**Subject: Route 5 Reconstruction and Minor Widening (West Springfield)
Project File No. 604210**

LivableStreets would like to take this opportunity to provide comments regarding the 25% Design for the Route 5 Reconstruction and Minor Widening Project in West Springfield. This stretch of Riverdale Street in West Springfield carries a significant amount of vehicular traffic and is currently very auto-oriented in its design and in the surrounding land uses. We therefore feel that every reasonable effort should be made to make walking, bicycling, and transit more appealing options, as well as to calm traffic and beautify the street as a whole.

Figure 3B-17. Examples of Yield Lines at Unsignalized Midblock Crosswalks

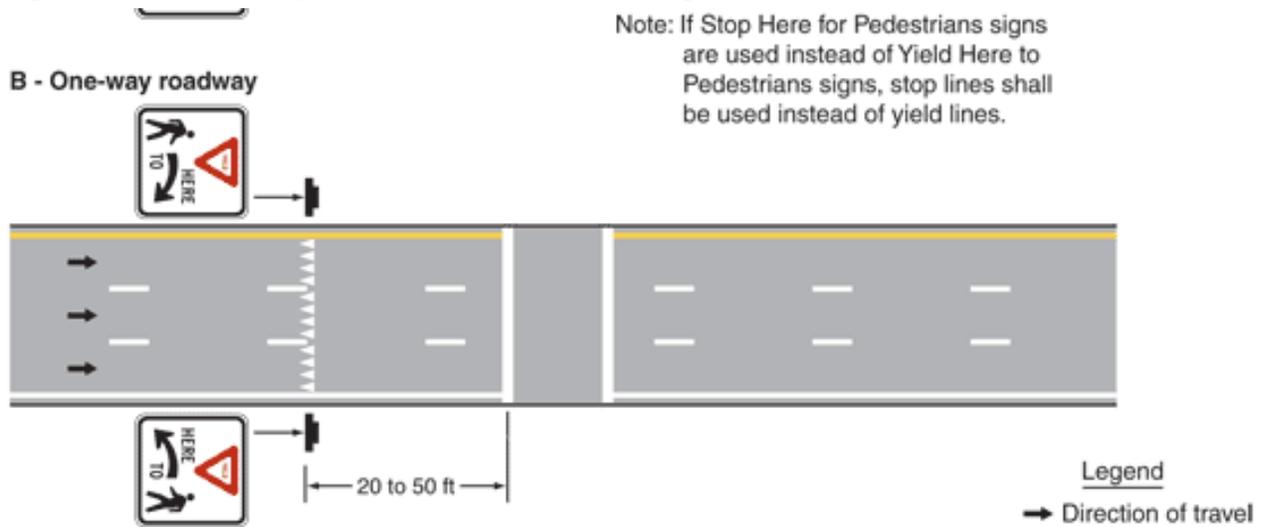
However, the entrance ramps to the southeast and northwest and exit ramp to the northeast are all heavily used and traffic tends to go quite fast along them. We are glad to see clearly marked zebra-striped crosswalks and appropriate pedestrian crossing signage prior to and at the crosswalks themselves. To the extent possible, we ask that you try to improve the ramp geometry to slow traffic and increase the visibility of pedestrians crossing the ramps. We also suggest the addition of **triangular yield lines prior to the crosswalks and additional “Yield Here to Pedestrians” signage** to better alert motorists that they are expected to yield to pedestrians.

An example from the MUTCD:

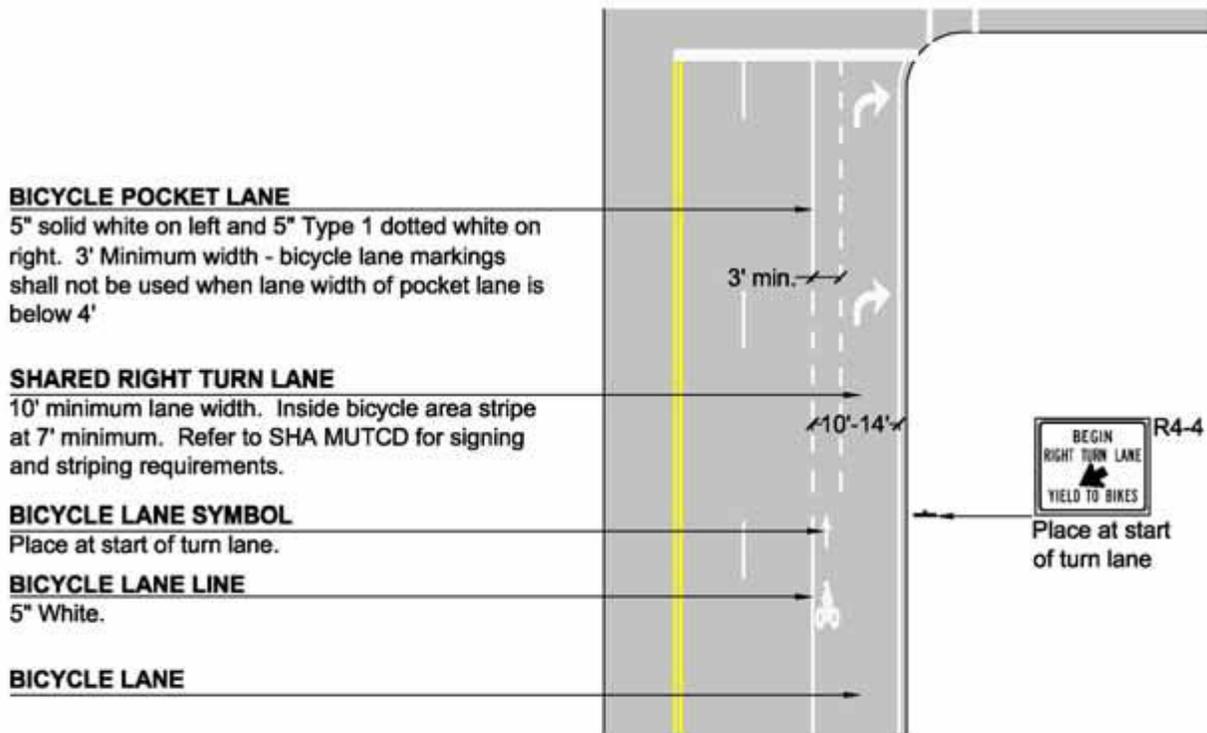
Based on the plans presented at the public meeting, this project will retain similar lane and shoulder configurations as currently exist. We **strongly suggest that bicycle lanes be added** to the roadway as part of this project, with the intention to extend them further along other segments in the future. Bicycle lanes would help to guide cyclists through the intersections, particularly where there are right-turn-only lanes and highway on-ramps and will help to make motorists aware that bicyclists are allowed and should be expected to use the roadway. We believe that the addition of bike lanes to this project is well supported by the MassDOT Highway Design Guidebook, which states:

Bicycle lanes are generally considered the preferred treatment for bicycle accommodation. (Section 5.3.2.1)
